**Cross River Rail Project:**  
**Coordinator-General's change report**  
**June 2017**

The proponent submitted a project change application to the Coordinator-General on 5 December 2016 requesting an assessment of changes to the project under Division 3A, section 35B, of the SDPWO Act. The project change application addresses the requirements of section 35E of the SDPWO Act, in that the written application describes the proposed changes and their effect on the project, states reasons for the proposed changes and includes enough information about the proposed change and its effects on the project to allow the Coordinator-General to make the evaluation. In accordance with section 35C of the SDPWO Act, the Coordinator-General has evaluated the environmental effects of the proposed changes, their effects on the project and any other related matters, and prepared this Coordinator-General's change report.

Figure 5.4 Proposed Albert Street Railway Station<sup>6</sup>

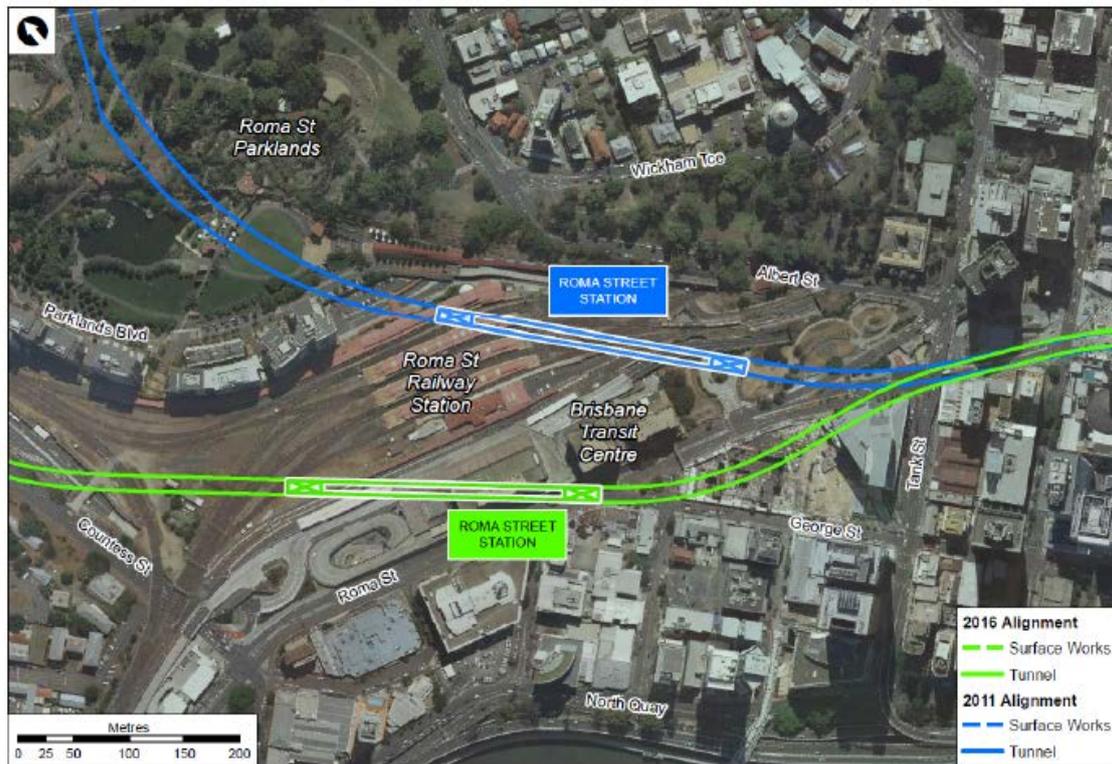
The changed project proposes to relocate Albert Street station one block to the north-west, closer to Alice Street compared with the original project (refer to Figure 5.4). Associated with the change in station location in Albert Street, sections of Albert Street between Mary Street and Elizabeth Street are proposed to be closed to vehicle traffic. This proposal would also require the relocation of the Myer Centre car park exit to Charlotte Street between Albert Street and George Street.

**Figure 5.6 Proposed Roma Street intersection layout<sup>8</sup>**

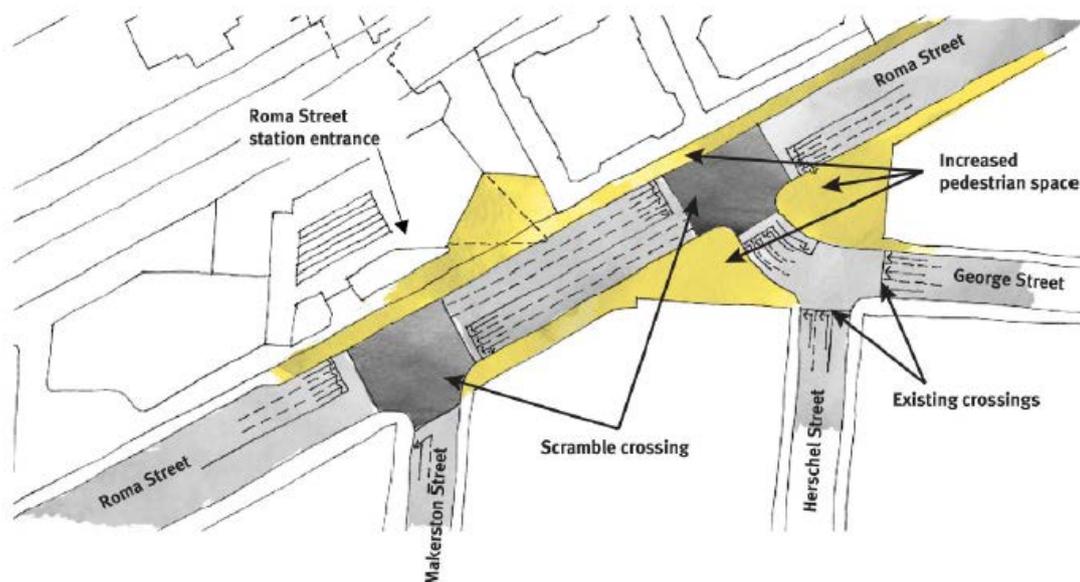
The change application also includes variations to the pedestrian access arrangements along Roma Street. The proposed conceptual layout (see Figure 5.6) includes the creation of a signalised T-intersection of George Street and Roma Street that will include a scramble pedestrian crossing. The T-intersection would be created through the re-alignment of George Street and Roma Street and the removal of the short section of Herschel Street between George Street and Roma Street.
